RE: January 31, 2007 DOGM Response on Additional Information Submitted by
KUCC on the North Tailings Expansion Optimized Phase 2 Finger Drain System,
Task #1667, M/035/015, Salt Lake County, Utah

**ADDITIONAL INFORMATION
NORTH TAILINGS EXPANSION OPTIMIZED PHASE 2 FINGER
DRAINAGE SYSTEM**

PERMIT M/035/015

ADDITIONAL INFORMATION FOR THE NORTH TAILINGS EMBANKMENT OPTIMIZED PHASE 2 FINGER DRAIN DESIGN

Figure 1: North Tailings Embankment Cross Section and Construction Zones for the Drainage Blanket and Drainage Fingers.

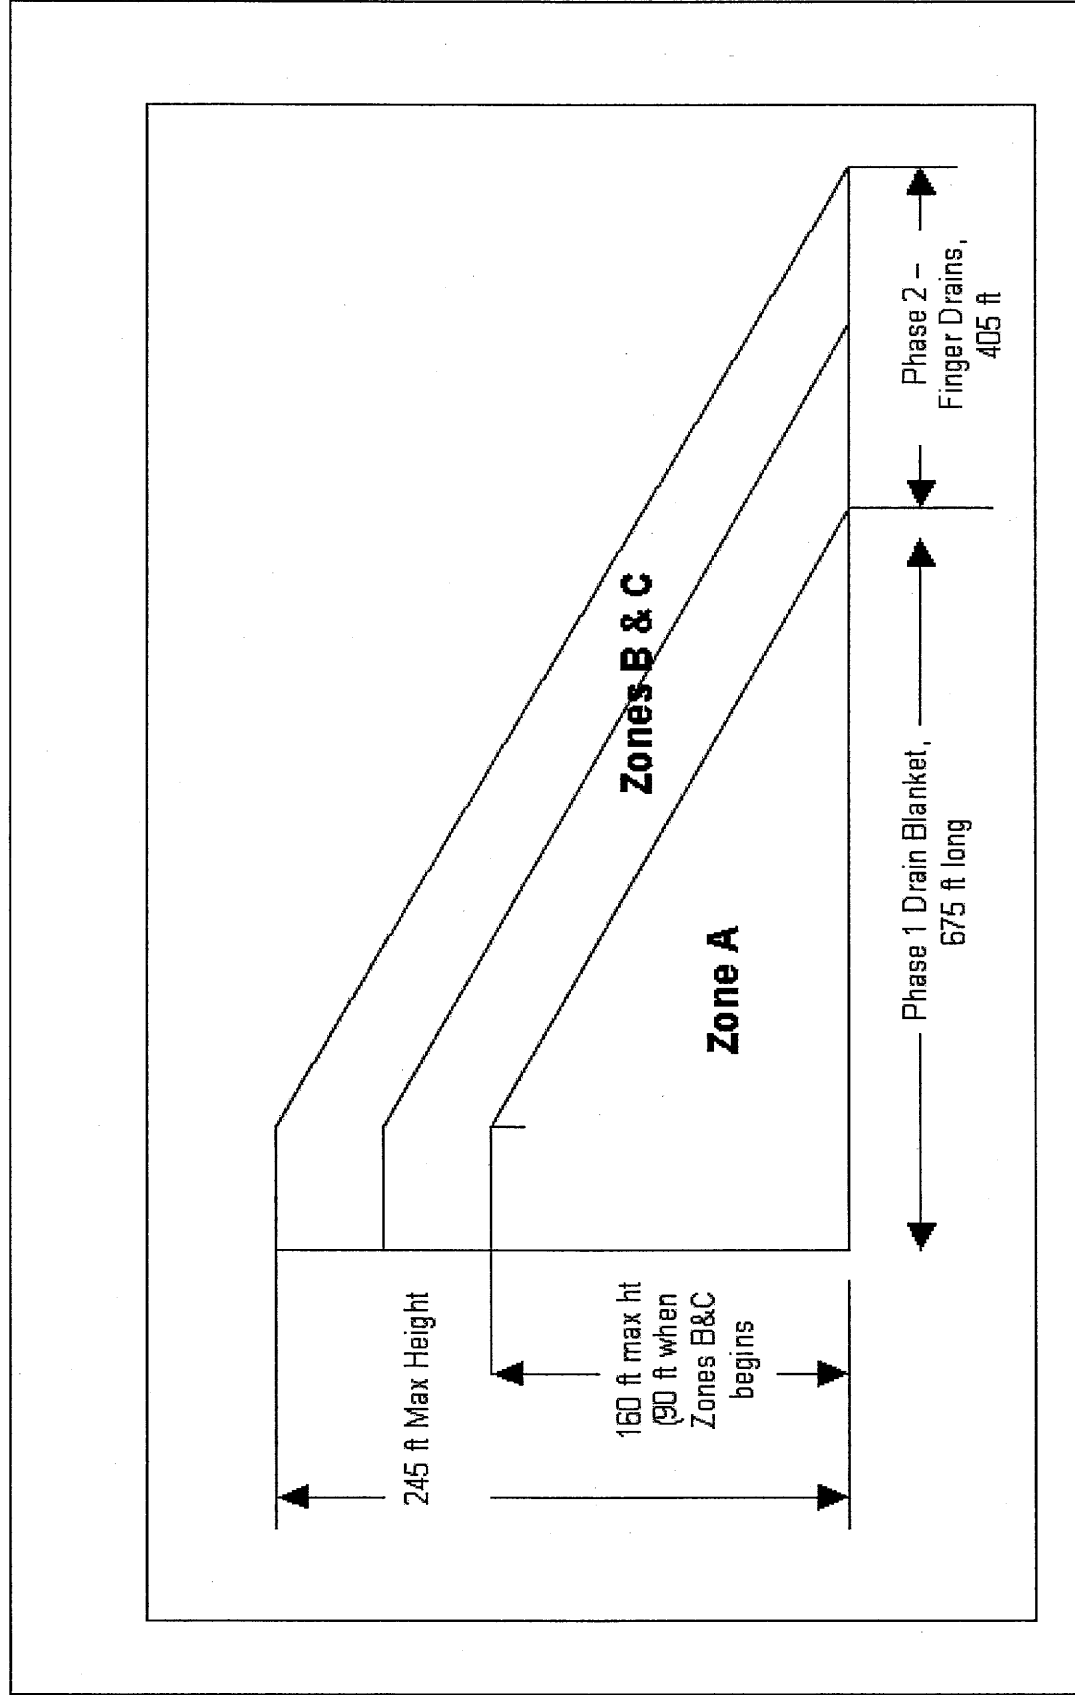
Phase 2 construction includes Zones B&C. The Phase 2 under-drain system was originally designed similar to Zone A, however an optimized under-drain system was required. A cross section of the North Embankment is shown in Figure 1. Instead of a drainage blanket, it was determined that the optimized Phase 2 finger drain system could be constructed.

Both the drainage blanket and drainage fingers will facilitate drainage within the embankment and foundation. Similar to the embankment, the drainage system was also originally designed to be constructed in two phases. This was to allow observation of geotechnical performance of the Phase 1 drain prior to finalizing design and construction of Phase 2. Following five years of operation (1999 – 2004) and monitoring of the Zone A embankment and Phase 1 drainage system, the Phase 2 drain design was optimized. The optimization resulted in drain fingers for the Phase 2 area rather than a drain blanket. The drain fingers consist of 50-foot wide drains placed at 150-feet on center. A total of 242 drain fingers will be constructed in the Phase 2 expansion area and all drain fingers will be tied into the existing Phase I drain blanket.

The Phase I drainage blanket covers approximately 675 feet, while Phase 2 covers an additional 405 feet of the 1080-foot embankment footprint width. Both drainage systems have a total thickness of 3 feet and consist of a 10-inch layer of minus 2-inch drain rock underlain and overlain by layers of finer-graded filter materials. A typical drainage finger section is shown on Figure 2, while a plan view of the surveyed finger drains is shown on Figure 3.

TYPICAL DRAIN FINGER SECTION

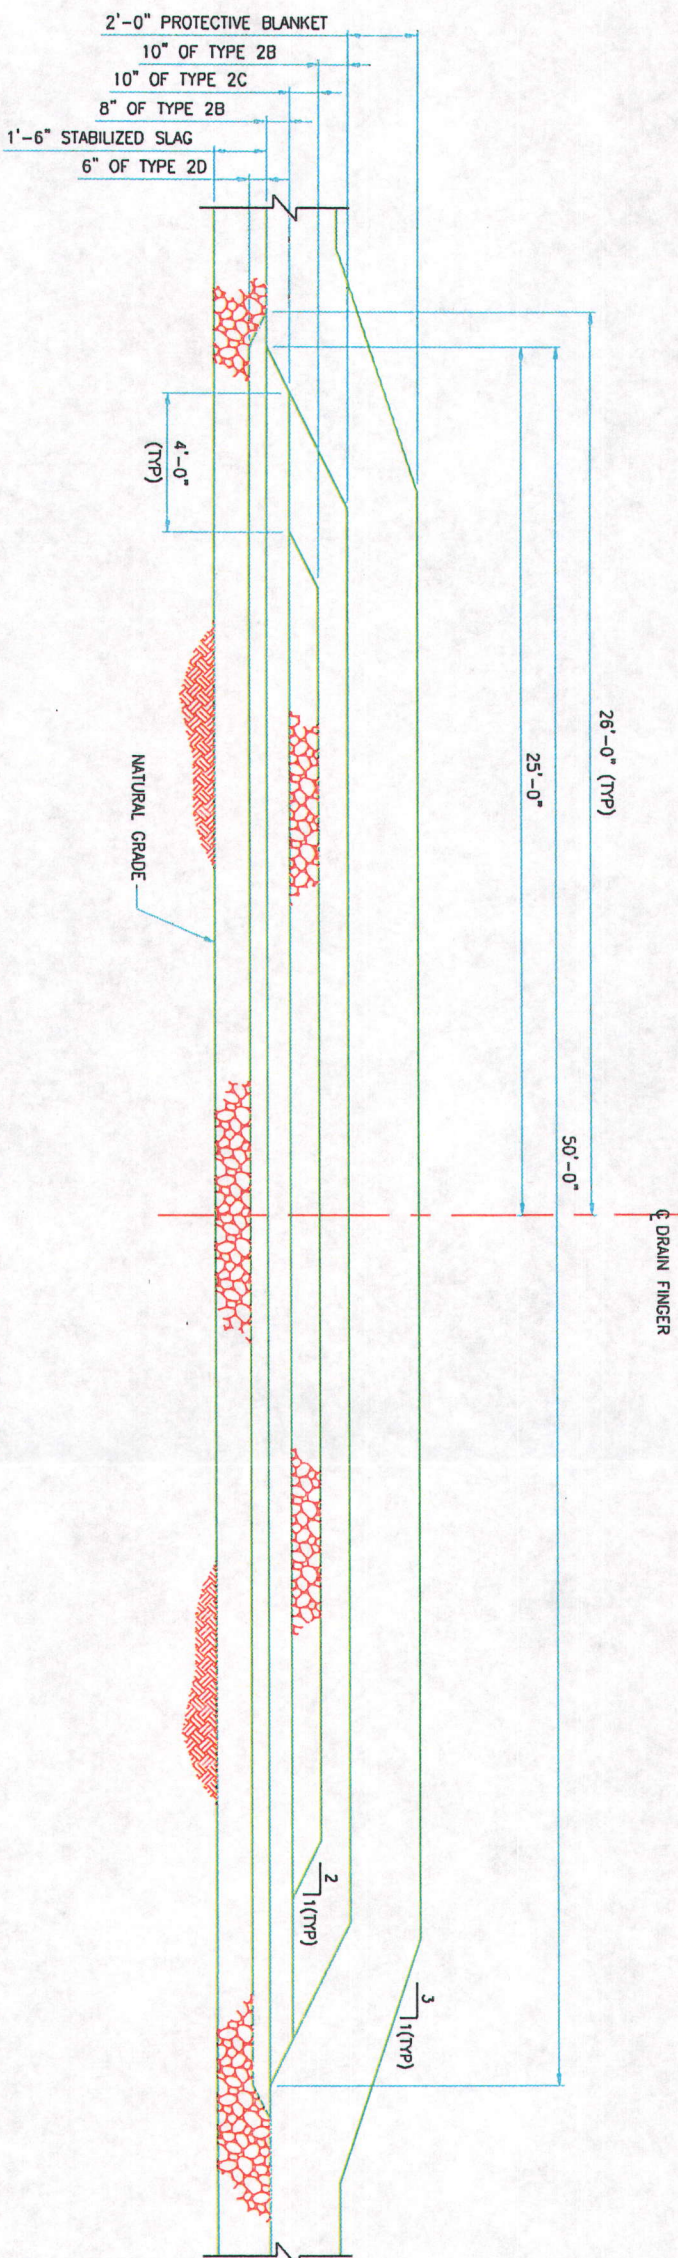
The phase 1 drainage blanket covers approximately 675 feet, while Phase 2 covers an additional 405 feet of the 1080-foot embankment footprint width. If a drainage blanket was constructed as part of Phase 2 it would also have been 405 feet. Both drainage systems have a total thickness of 3 feet and consist of a 10-inch layer of minus 2-inch drain rock underlain and overlain by layers of finer-graded filter materials.
